PHAP15-00048

Date:	January 11, 2016
Application Type:	Certificate of Appropriateness
Property Owner:	Peter Svarzbein
Representative:	Peter Svarzbein
Legal Description:	Being 21 Sunset Heights E. 60 Ft. of 9 To 12 & E. 60 Ft. of N. 20 Ft. of 8, City of El Paso, El Paso County, Texas
Historic District:	Sunset Heights
Location:	900 W. Yandell Drive
Representative District:	#8
Existing Zoning:	A-2/H (Apartments/Historic)
Year Built:	1955
Historic Status:	Non-Contributing
Request:	Certificate of Appropriateness for the connection of two separate balconies, forming one, larger balcony using metal pickets to match existing
Application Filed:	12/16/2015
45 Day Expiration:	1/30/2016

ITEM #2

PROPOSED PLAN AND ELEVATION

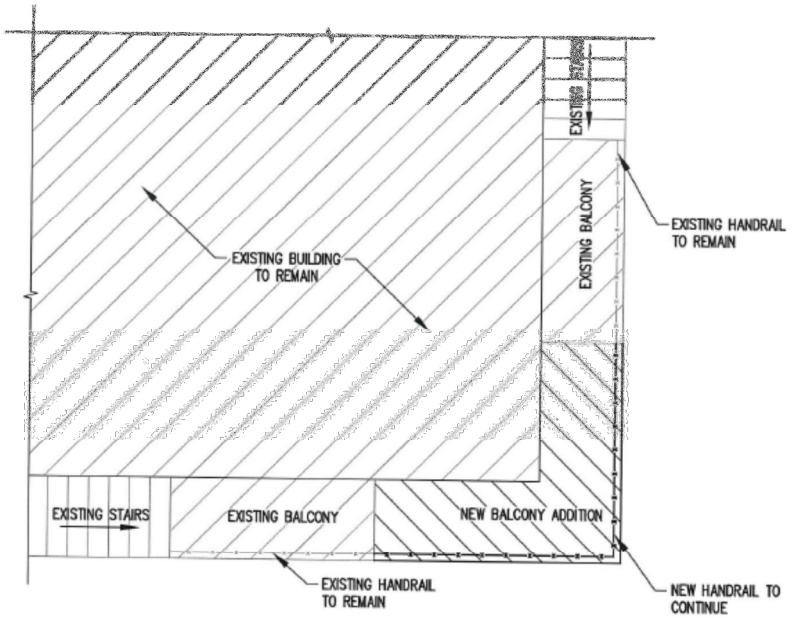
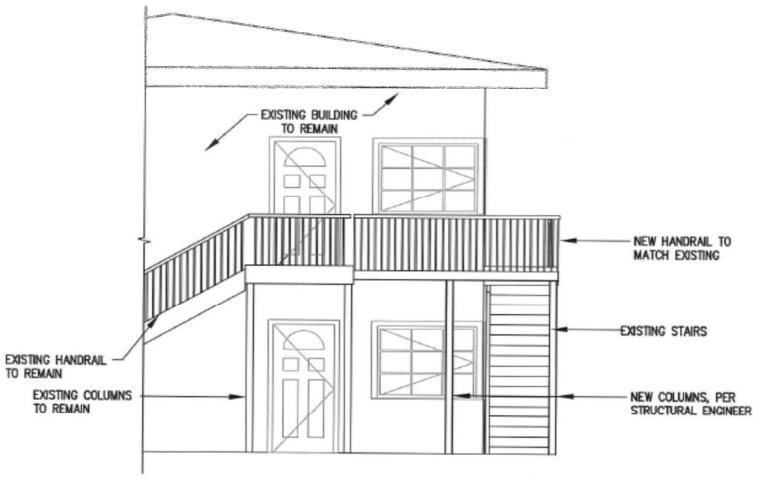
The Historic Preservation Office recommends that the application be postponed until a complete elevation of the new feature is submitted based on the following recommendations:
